Please see the responses to the comments received below.

LES SCHWAB TIRE CENTER CONSTRUCTION DOCUMENTS

7105 OLD MERIDIAN ROAD FALCON, COLORADO 80831

SITE DEVELOPMENT
PLANS

UTILITY PLAN

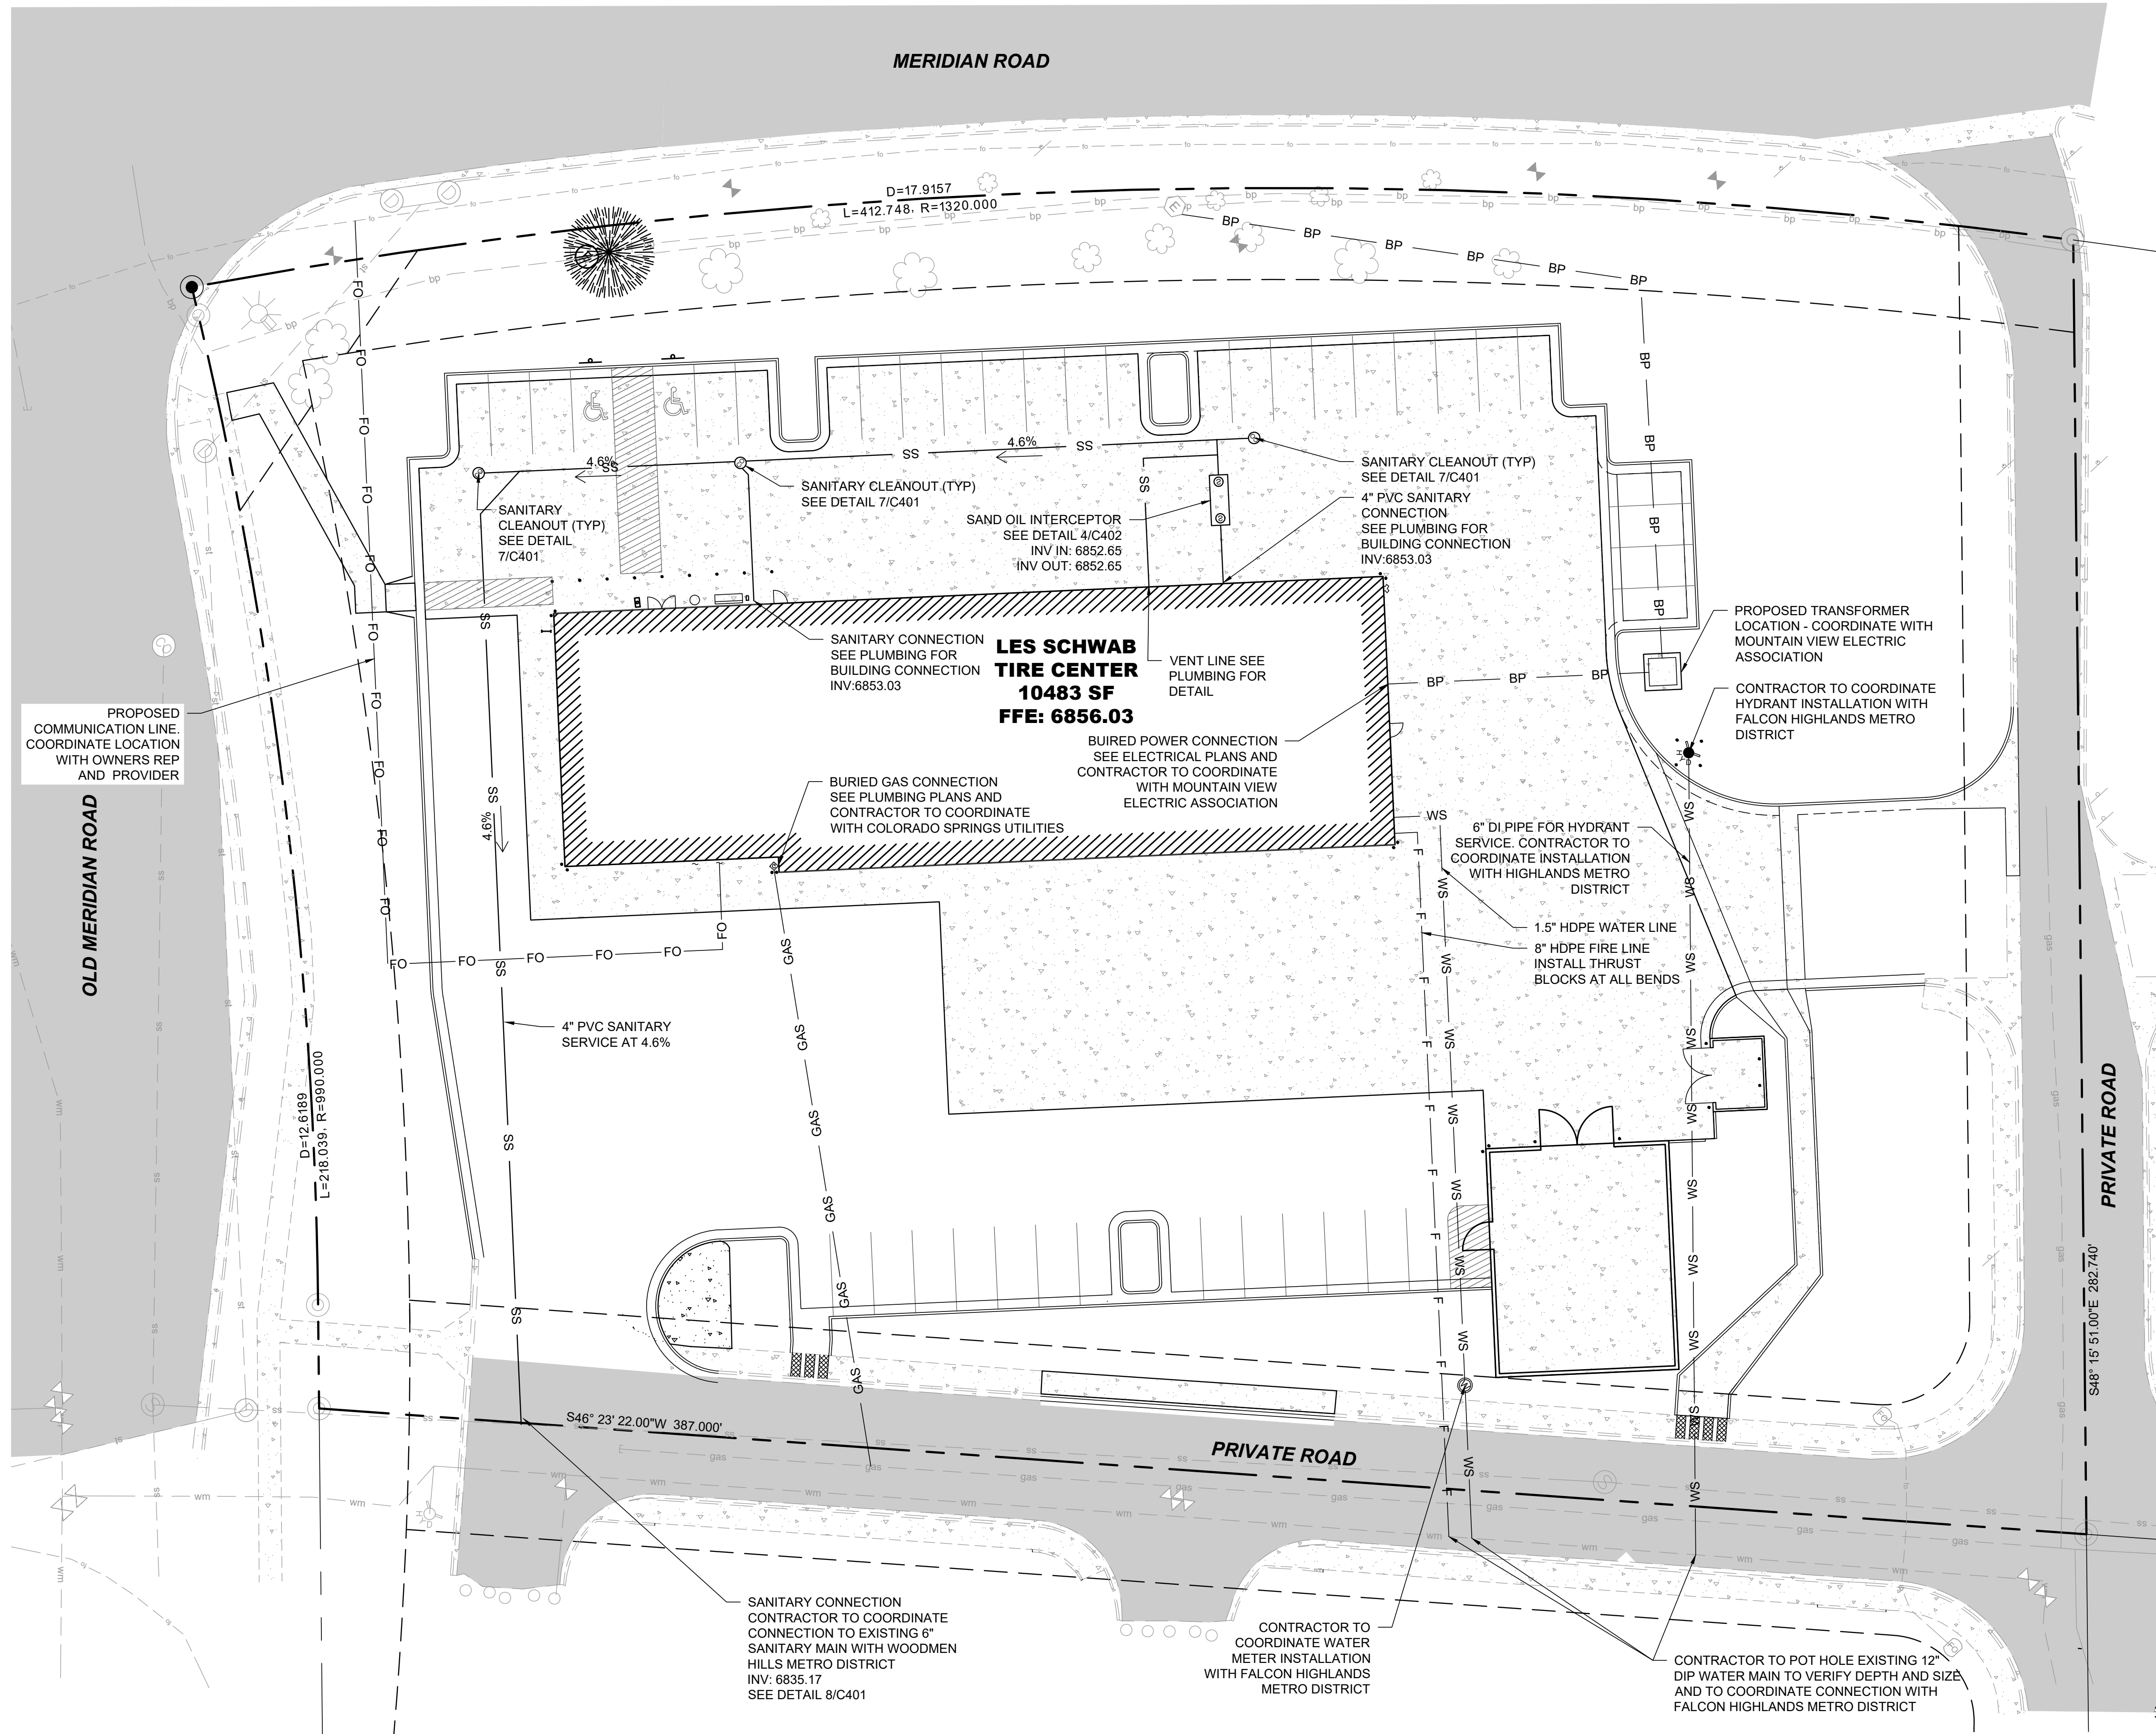
Please include the following general notes on the utility plan

Please include building elevation with the intended location of the gas meter. The gas meter will need 3 feet radial clearance from doors, operable windows, and sources of ignition.

Response: CSU general notes have been added to sheet C300

Response: Gas meter has been added to building elevations.
